NEDO-10958-A
Class I
January 1977

**GENERAL ELECTRIC BWR THERMAL ANALYSIS BASIS (GETAB):
DATA, CORRELATION AND DESIGN APPLICATION**

The Regulatory staff has completed its review of the General Electric Company proprietary topical report NEDE-10958, "General Electric BWR Thermal Analysis Basis (GETAB): Data, Correlation and Design Application". Enclosure 1 is the Regulatory staff's evaluation of this report.

Figure 12 LOCATION RESIDUAL VS. BOILING LENGTH FOR GEXL CORRELATION OF ATLAS DATA

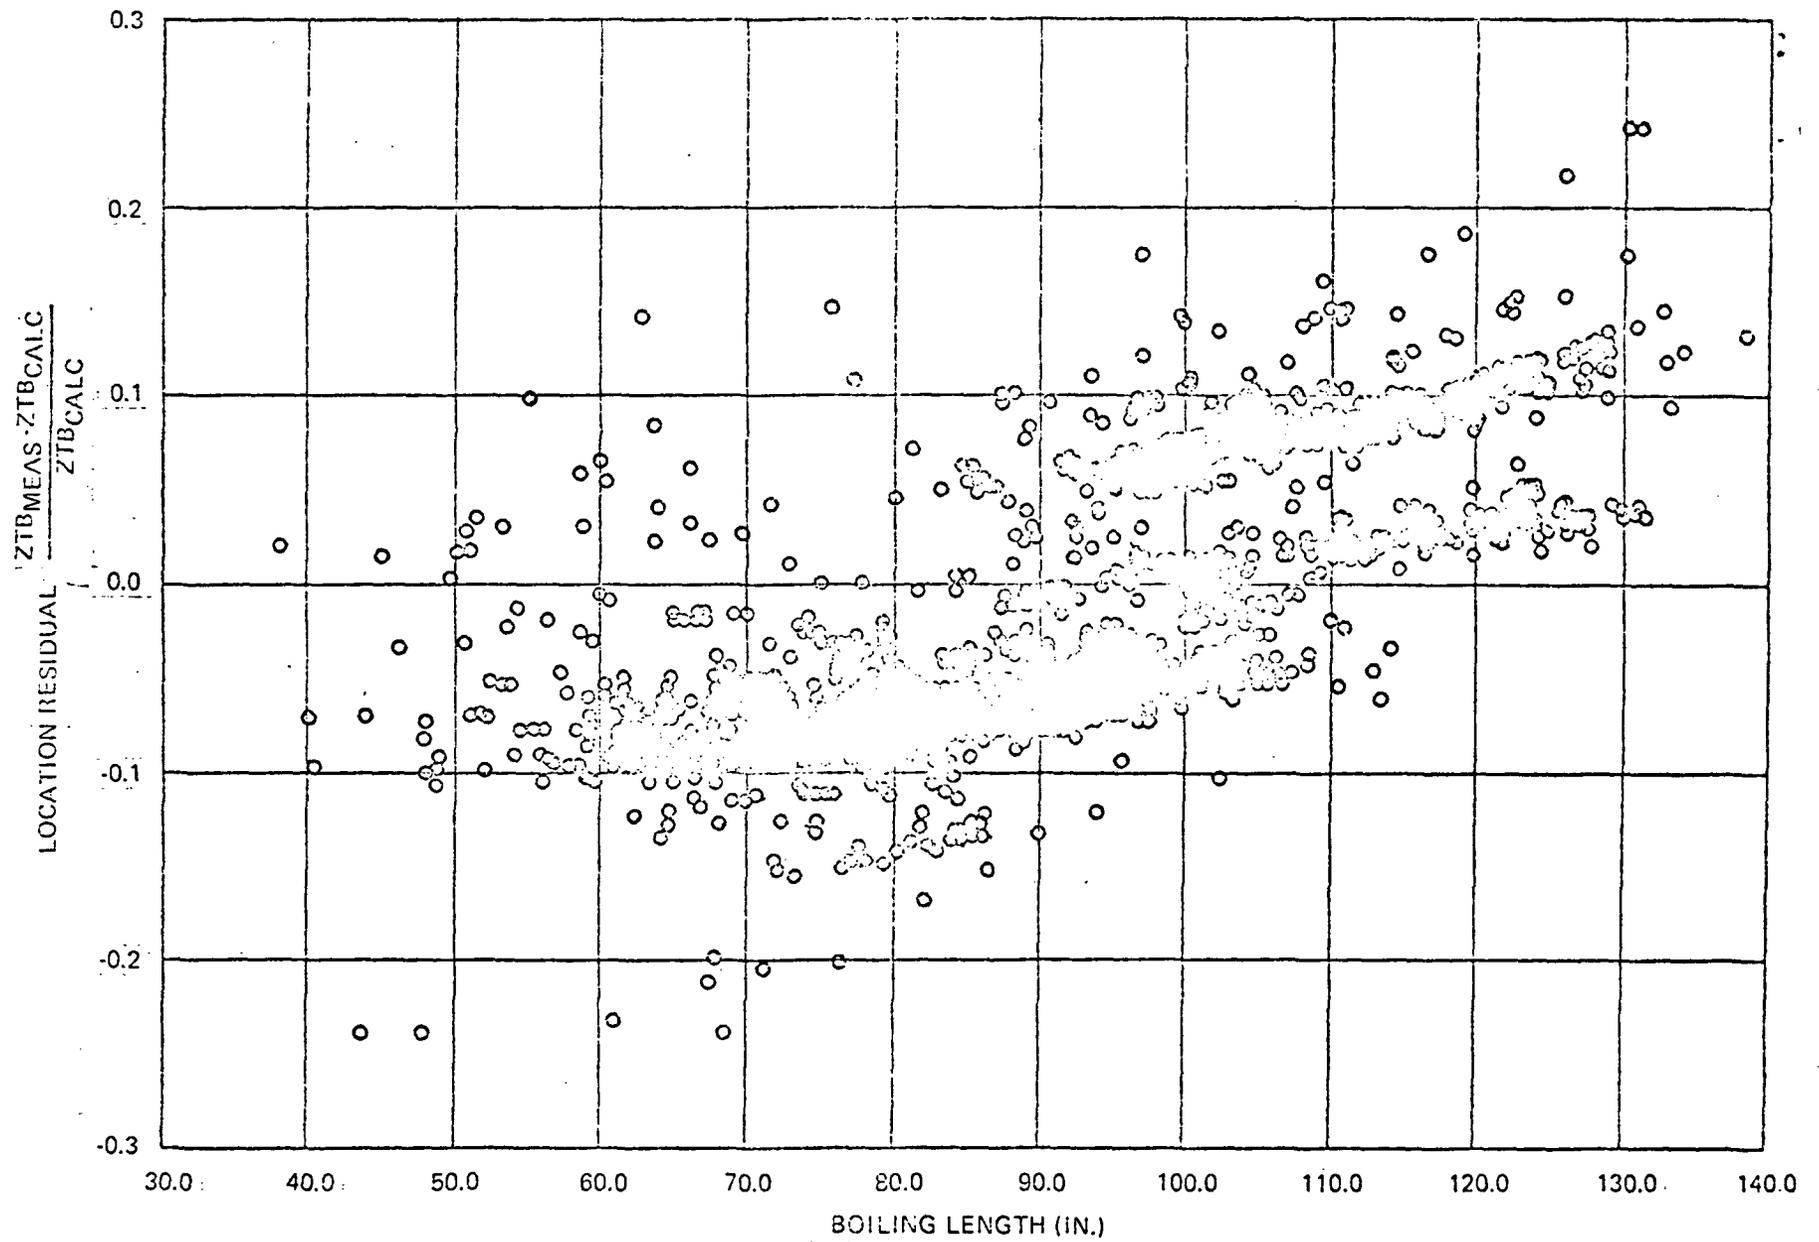
length is observed in Figure 12 where the location residual is plotted vs. boiling length. This figure shows that at shorter boiling lengths, the correlation, using the location predictor correction, generally predicts the location downstream of the measured position while, at the longer boiling length, the correlation generally predicts the location upstream of the measured position. The shorter boiling lengths are characteristic of the inlet peaked axial profile. Figure 13 shows the location residual vs. axial power shape. Generally, the scatter for the prediction of location is greater than for the prediction of power.

Figure 14 AXIAL FLUX SHAPES FOR 7 X 7 LATTICE

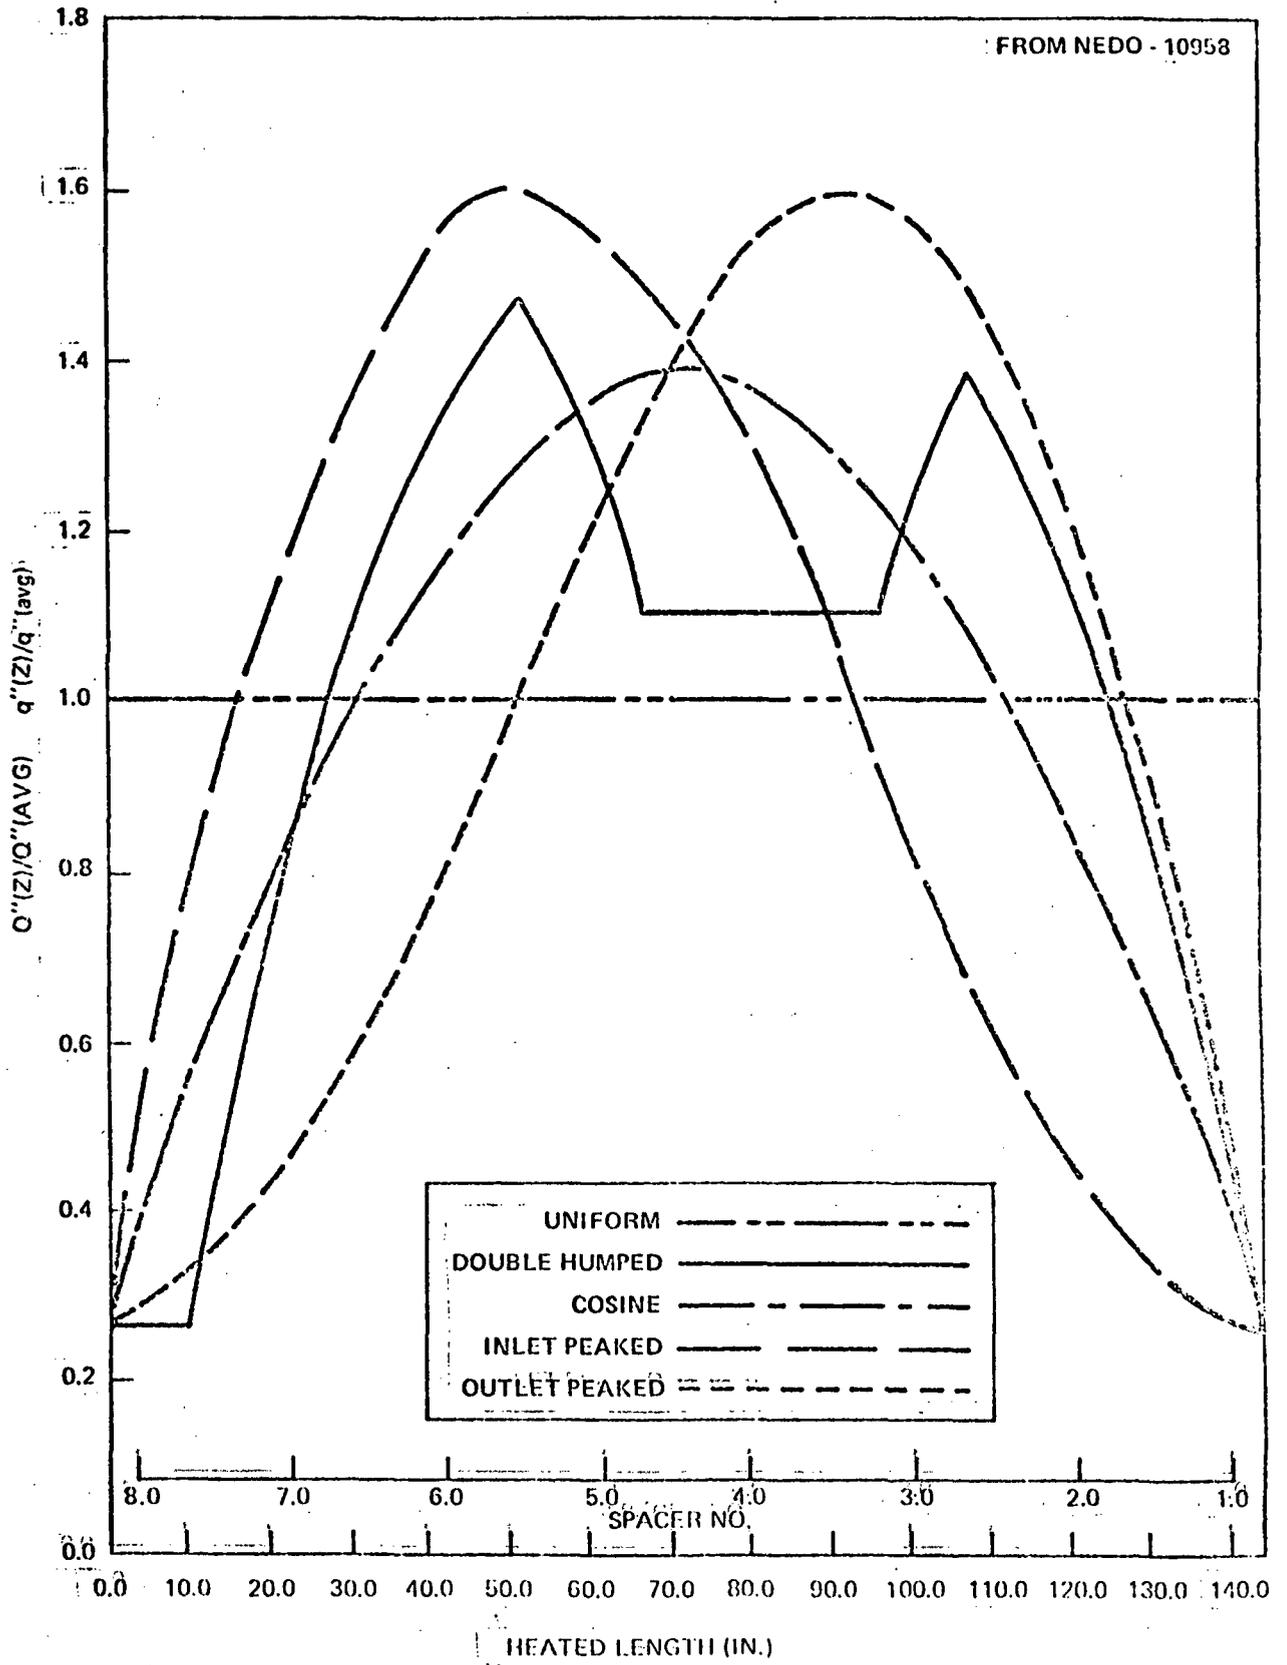
The axial flux shapes tested are those shown in Figure 14. They were chosen to represent the widest range of shapes anticipated during the core life. Considering the wide range of peaking factors included in the ATLAS program the tests appear to simulate as closely as possible the geometry and power distributions expected to occur in BWR fuel.
